TO: NUQAP Topical Report Copyholders
FROM: Rick Paliuca, QAS (Extension 6767 MP)
SUBJECT: Update to NUQAP Topical Report, Revision 17

NORTHEAST UTILITIES QUALITY ASSURANCE PROGRAM TOPICAL REPORT

CHANGE REQUEST FORM
SAMPLERequest No. 95-1Date 10/5/94Requestor William A. LacyI. PROPOSED REVISION1. GENERAL DESCRIPTION OF CHANGE

FIGURE 1.4

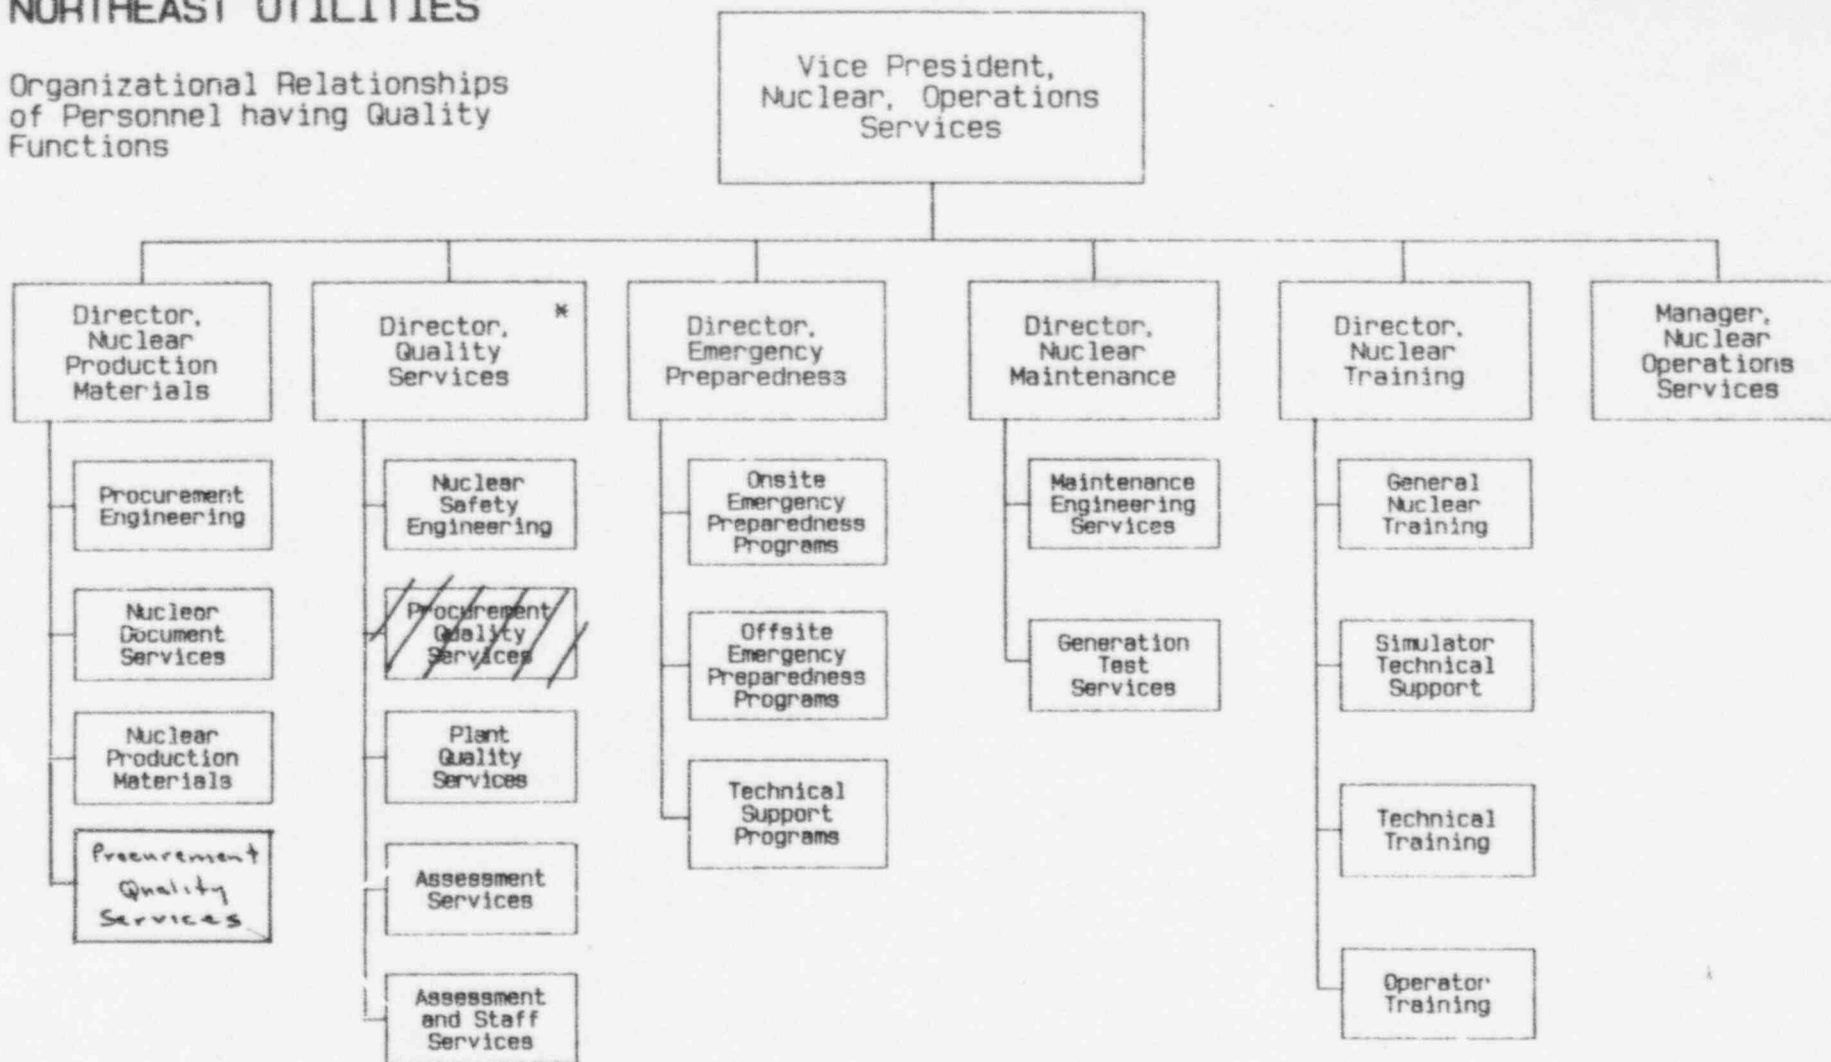
1.4.2 The Vice President-Nuclear, Operations Services is responsible for Nuclear Production Materials, Quality Services, Emergency Preparedness, Nuclear Maintenance Programs, and Nuclear Training. The following department Directors report to the Vice President-Nuclear, Operations Services (see Figure 1.4):

1.4.2.1 The Director-Nuclear Production Materials is responsible for parts, materials, ~~and~~ records support services, *and procurement of equipment and material* as required for NUSCO/NUPOC Departments during the design, modification, maintenance, construction, and operation of nuclear power plants.

FIGURE 1.5

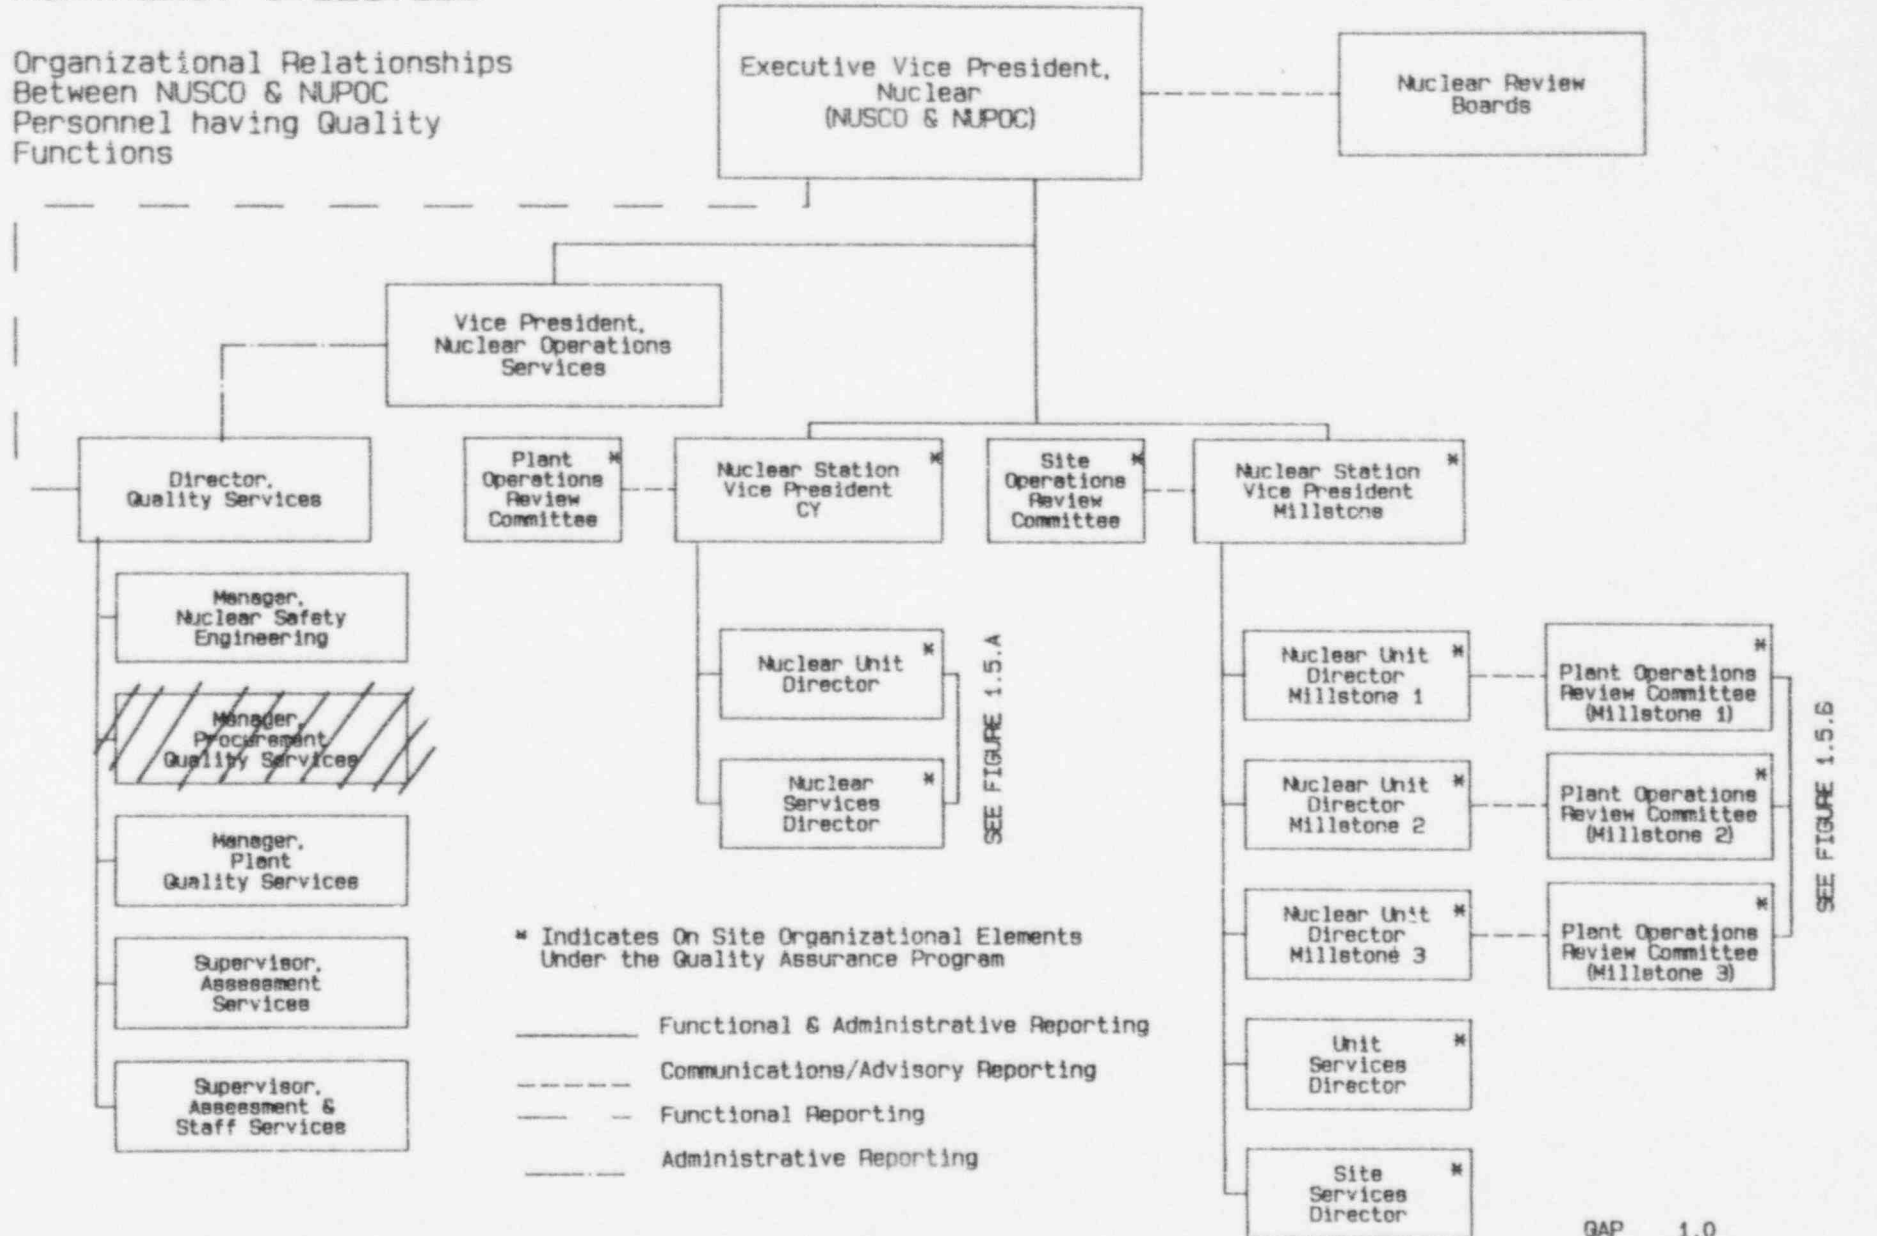
Section/Appendix	1.0	Paragraph No.	1.4.2.1
		Figure	1.4
		Figure	1.5
	2.0		2.2.4
			2.2.5
	3.0		3.2
	4.0		4.2.1
			4.2.3
	5.0		5.2
	6.0		6.2.1
			6.2.2
			6.2.3
			6.2.4
	7.0		7.2.1
			7.2.2
			7.2.3
			7.2.4
			7.2.5
	8.0		8.2
	9.0		9.2
			9.2.2
	10.0		10.2.1
	11.0		11.2.1
			11.2.4
	12.0		12.2.1
	13.0		13.2.1
